**Review of the
Mixed Hazardous Radioactive
CERCLA
Waste Cleanup Policy at the
Radioactive Waste Management Complex
Subsurface Disposal Area
Department of Energy's
Idaho National Laboratory**

Submitted by
Chuck Broschius

on behalf of
Environmental Defense Institute
July 2018 Rev. 3.4

Figure 3-4. Transuranic and low-level waste disposal locations in the Subsurface Disposal Area.

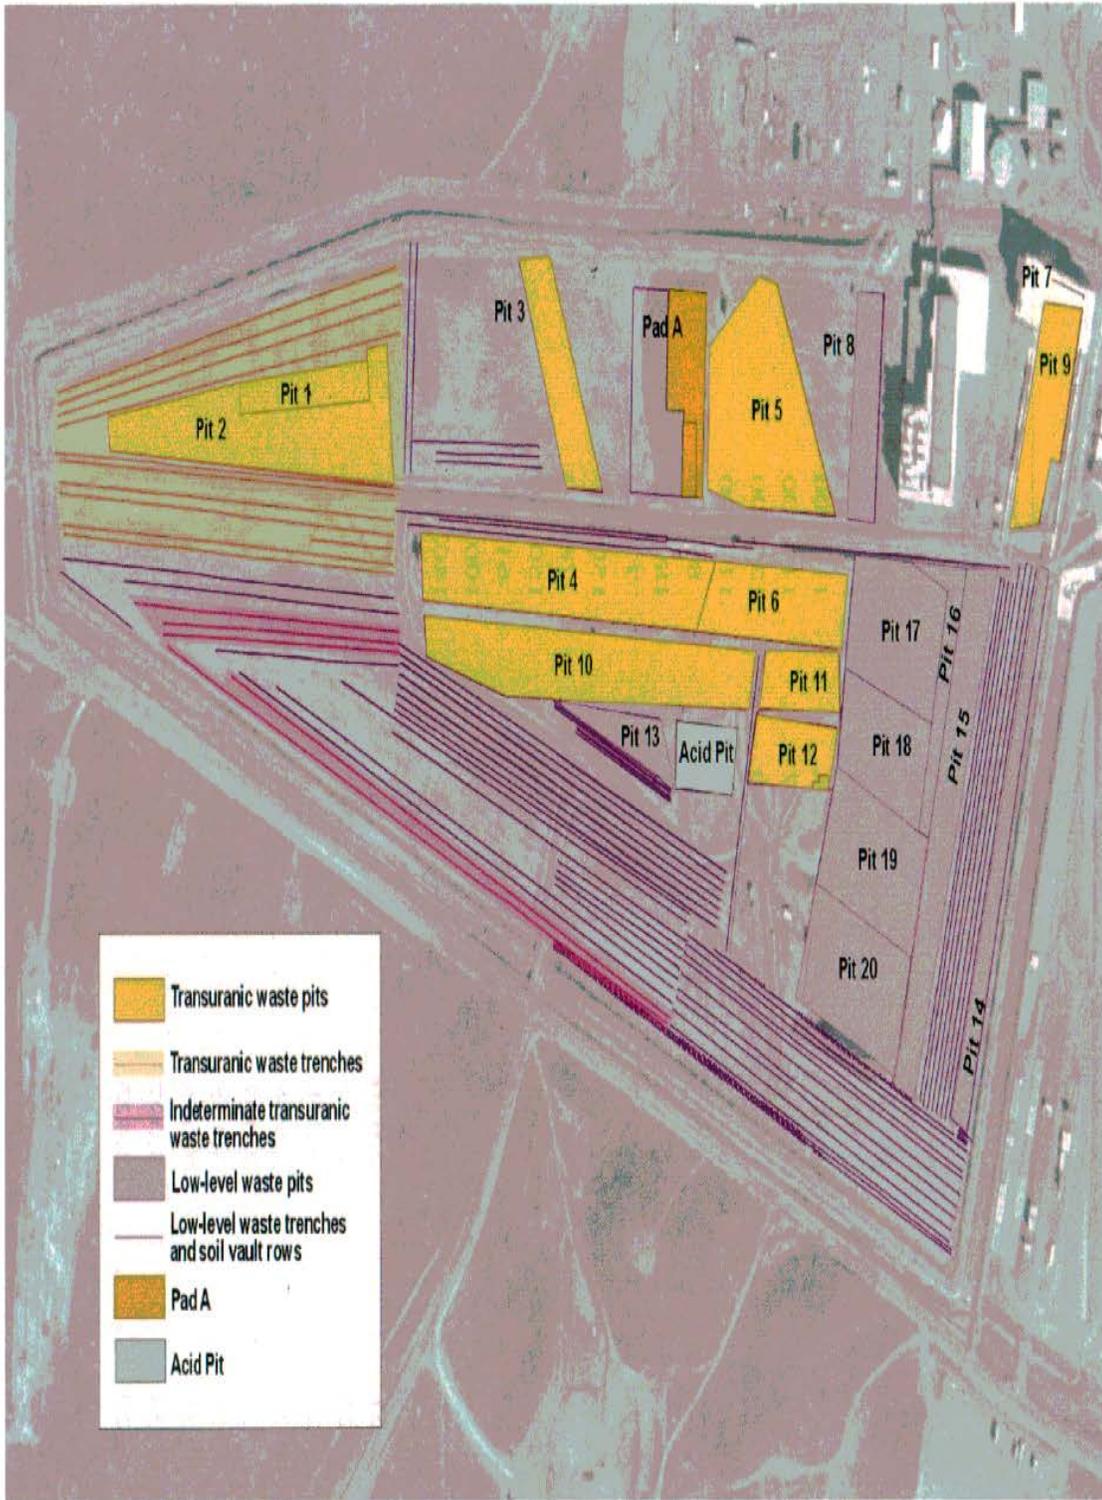
Figure 3-4 above shows the transuranic and low-level waste disposal locations in most of the Subsurface Disposal Area. It is an important visual to better understand just how wide spread TRU waste is distributed throughout the SDA and that will mostly remain buried.³⁸ DOE/INL have always denied that high-level (irradiated reactor fuel) waste and the remains of the 52 reactors built/tested at INL, were dumped in the SDA and it is of no focus for the “targeted waste retrieval” cleanup program. In fact Idaho Governor Otter reinforced this secrecy in the “Agreement to Implement” goes further by stating that waste retrieval operations must be suspended when it “implicates national security issues involving classified information, such factors constituting the exclusive basis upon which DOE may request the suspension of a retrieval obligation under this Agreement.”³⁹ These issues are discussed in Section III below.

Figure 4-2. All-pathways effective dose equivalent 100 m downgradient from the Radioactive Waste Management Complex boundary from year 2110 to year 100,000 with cover infiltration rate equal to 1 cm/year.

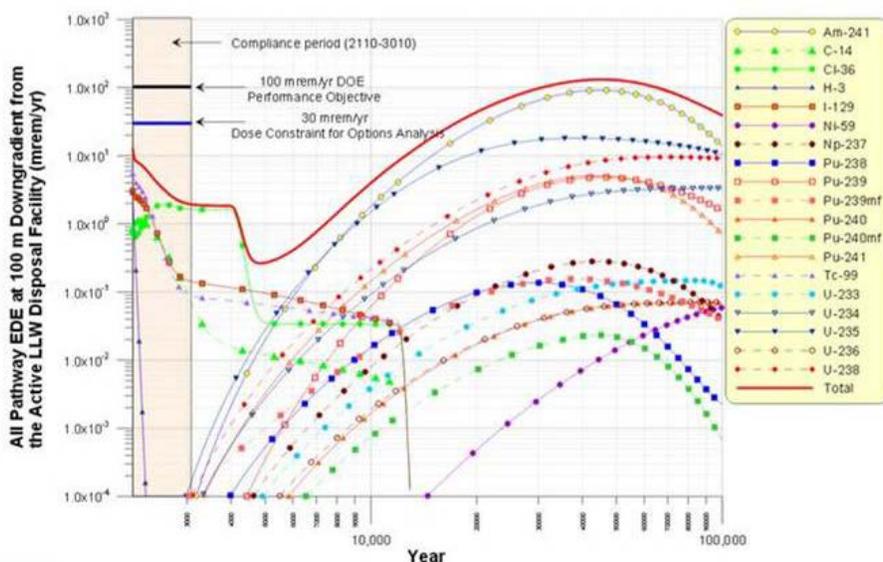
“The graph of the migration of the buried waste at RWMC that will remain at RWMC buried in soil is shown below in Figure 1. The contamination migration is not realistically modeled by the DOE nor is it conservatively modeled. Flooding and fast paths of contaminant migration are ignored.⁸⁸ The ingestion doses will undoubtedly exceed the 30 to 100 mrem/yr radiation doses shown, intermittently at least. The CERCLA cleanup ignored doses after 10,000 years. Check out how, even after 100,000 years, the long lived radioactive waste, including americium-241, various plutonium and uranium isotopes, iodine-129, neptunium-237 and technetium-99, remains an ingestion hazard, even with the modeling assumptions biased toward retention in the burial grounds.”

Figure 1-2. Overview layout of the Radioactive Waste Management Complex, including the Subsurface Disposal Area, Transuranic Storage Area, and Administrative Area.

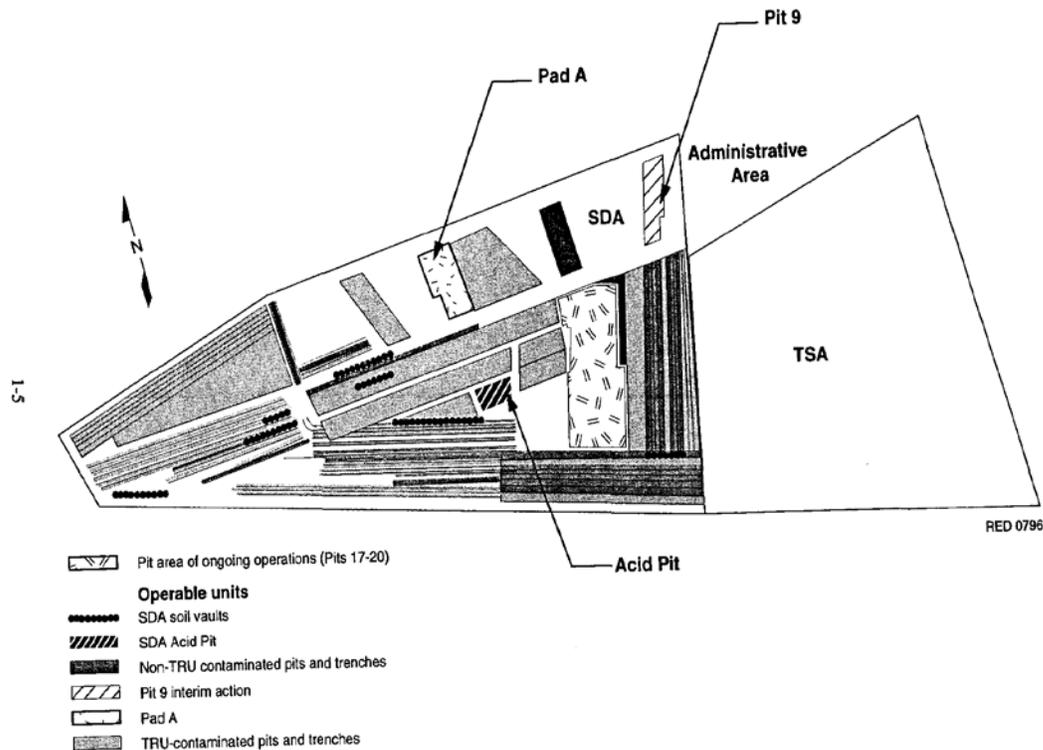
The importance of the below Figure 1-2 shows how extensive TRU waste is distributed in the SDA pits and trenches that radically contrasts the current DOE characterization of limited TRU waste for “retrieval.” Attachment A to this report offers more details on this issue.
